Planning Officer: Miss Z Toppin
Planning Application Ref: **AW/253/20/T**
Location: **14 Old Farm Close, Aldwick**
Description of works: **Reduce height of 1No. maple tree to approx. 10m**
Reasons given: To prevent nuisance to public highway users

Figure 2 Positions of final cuts

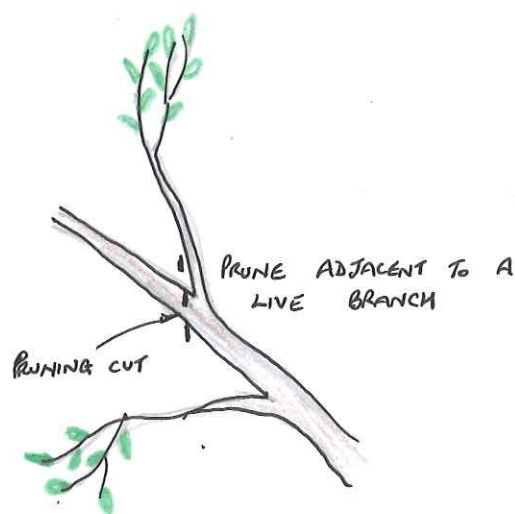
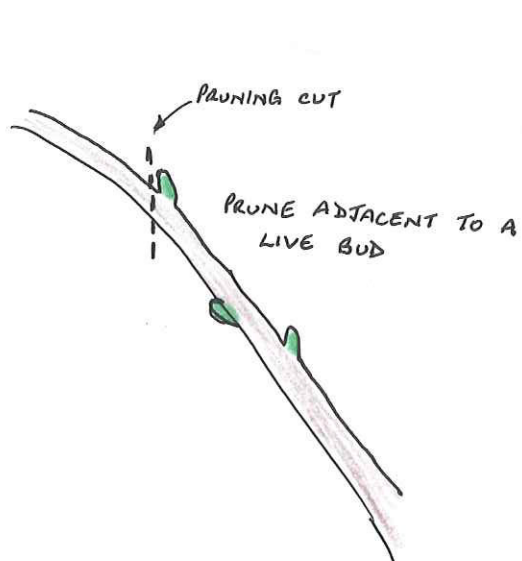
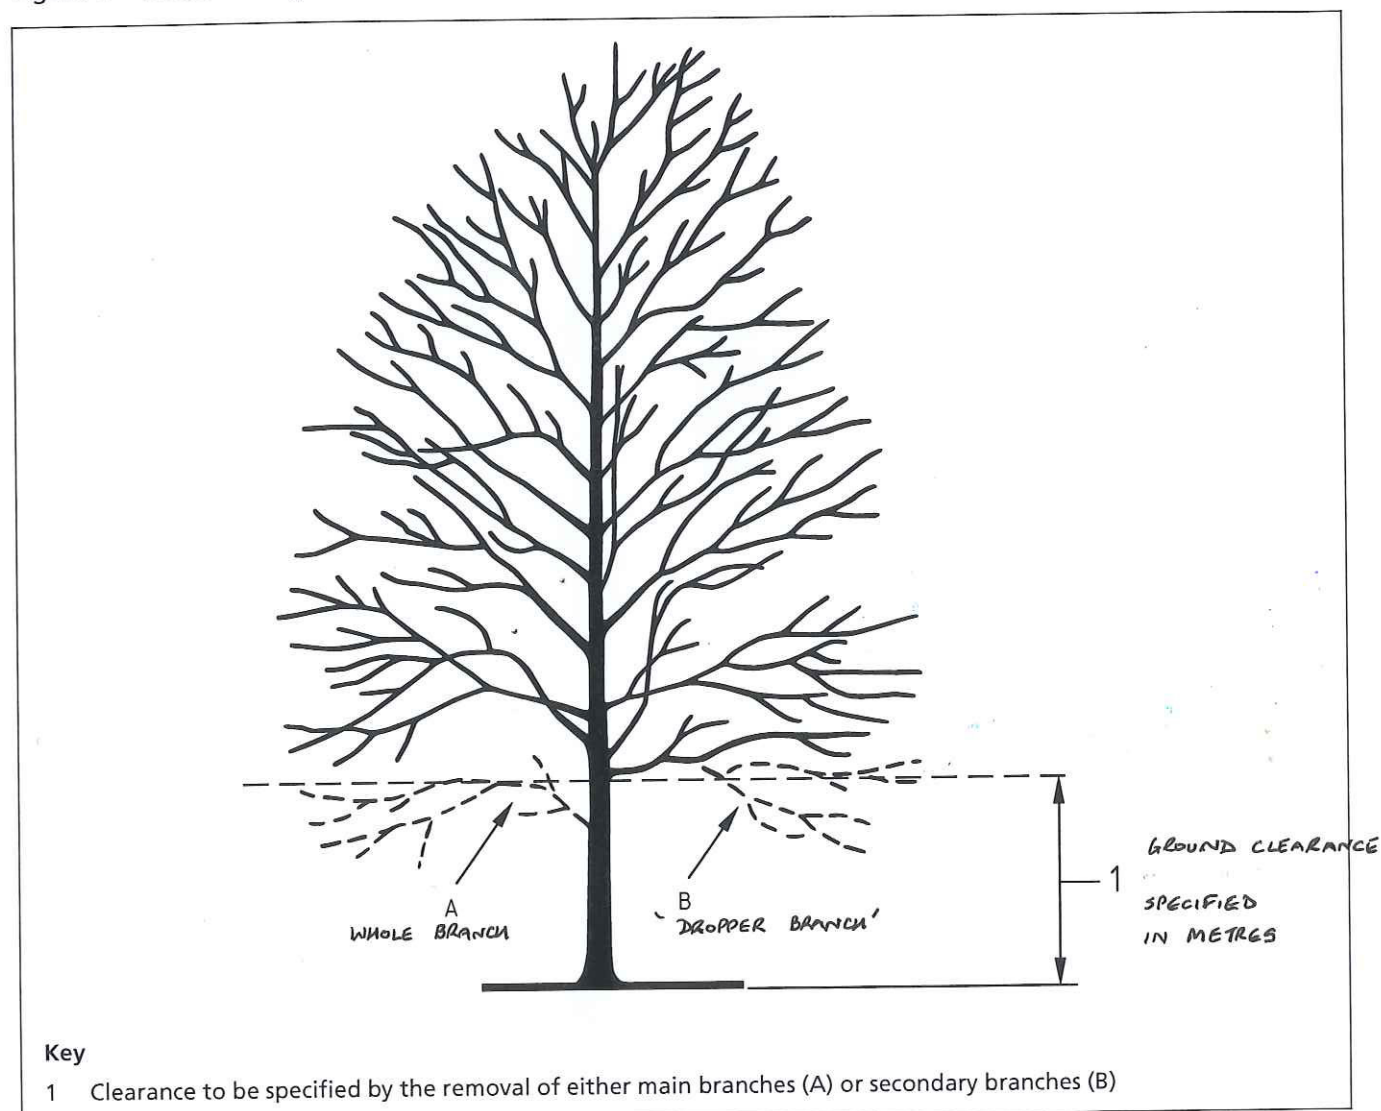
- Part a) Where whole branches are to be removed and final cuts made close to the trunk or branch union they are to be made as shown in Figure 2 of BS3998:2010
- Part b) Where branches are to be shortened back the final cuts are to be made at the correct angle shown in BS3998:2010 and adjacent to a live bud or lateral.
